BADGER SCHOOL

Subject: Opening in wall between Door 6 and Door 8

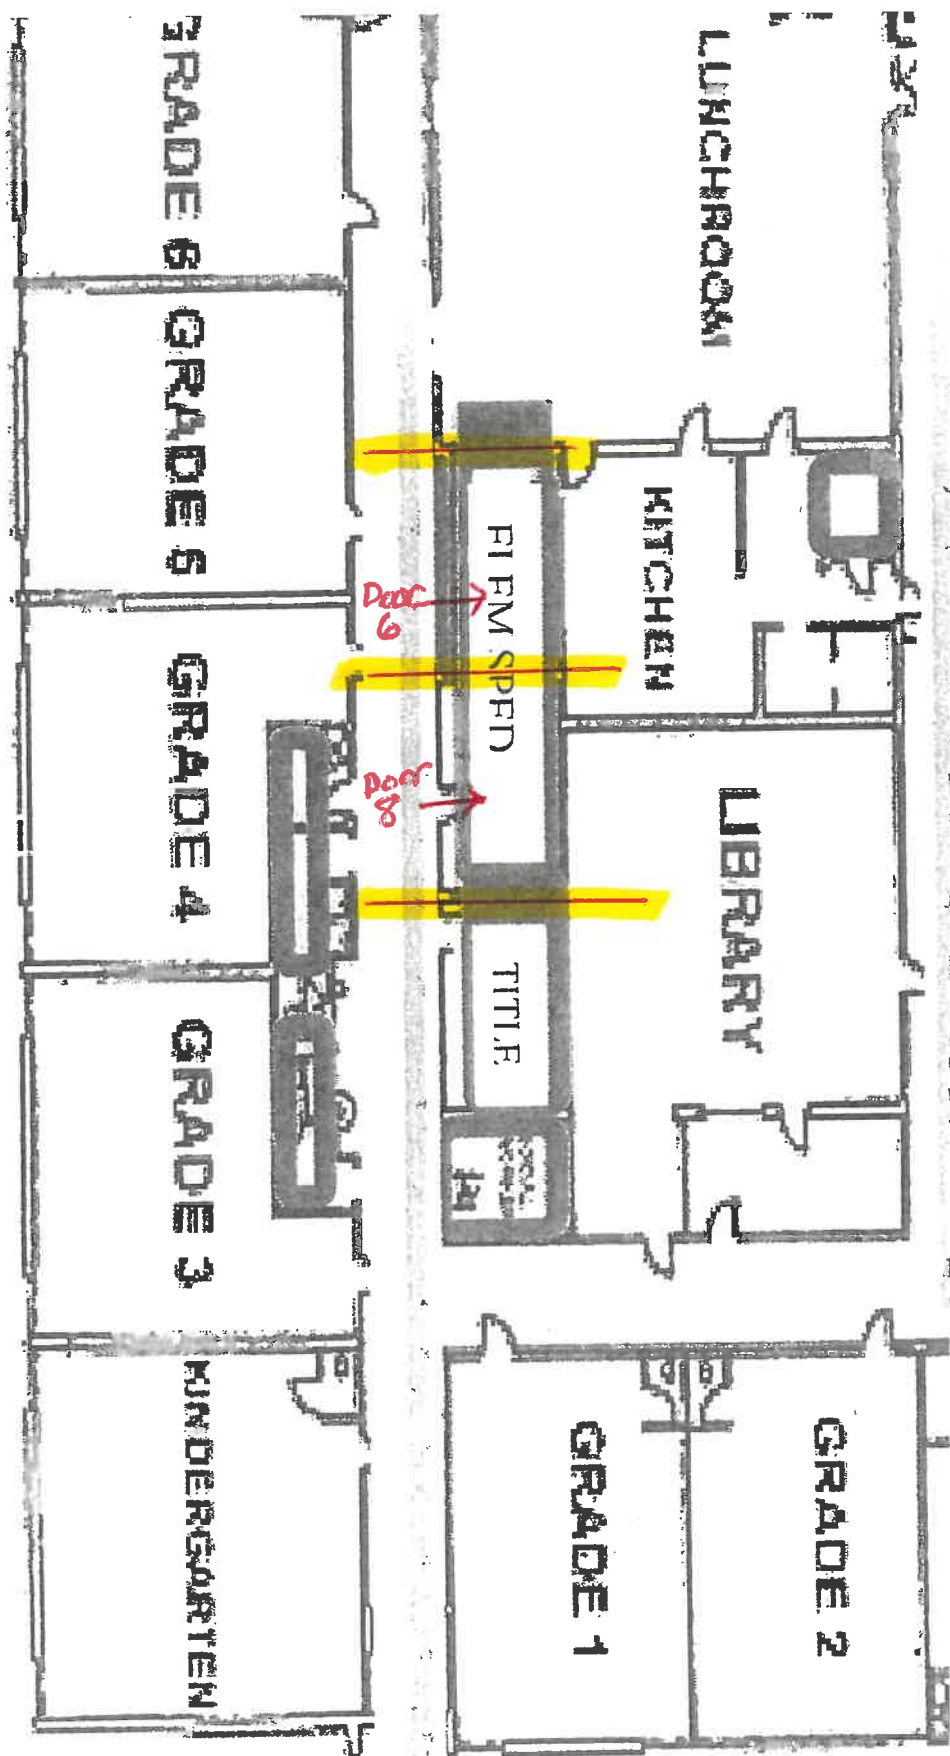
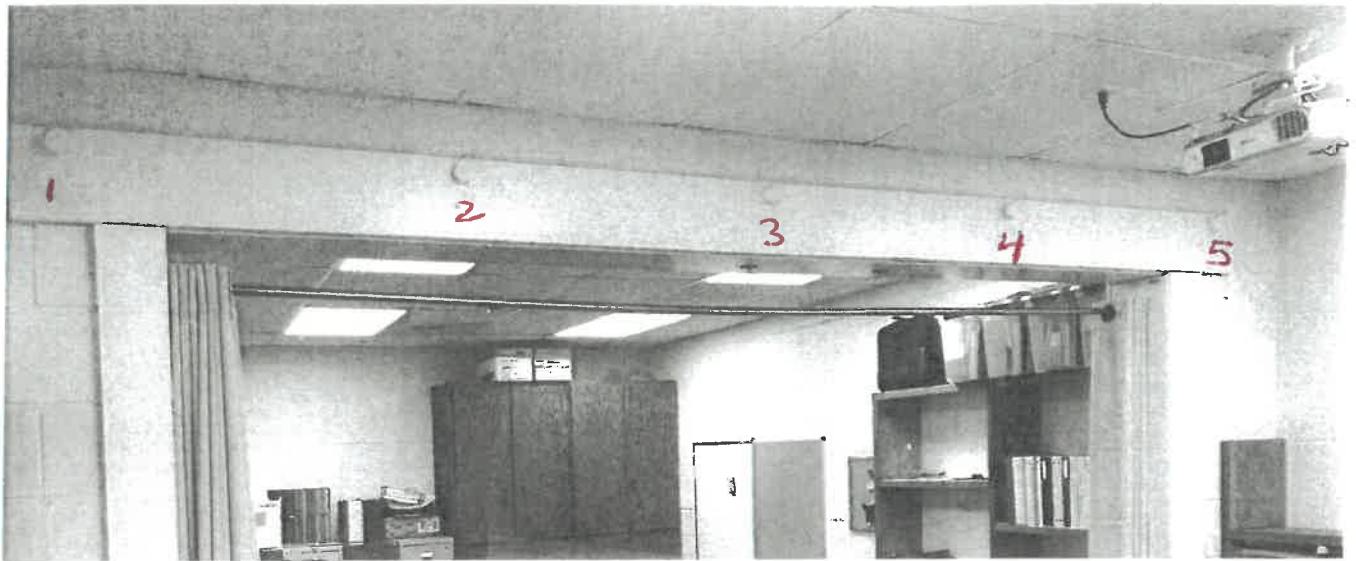
Explore
framing/sheetrocking
a sound-reducing
closure to
create a separate
space?

5 1/2-inch diameter anchor bolts - welded solid

Iron steel beams/plates

Opening must be through a load-bearing structure wall
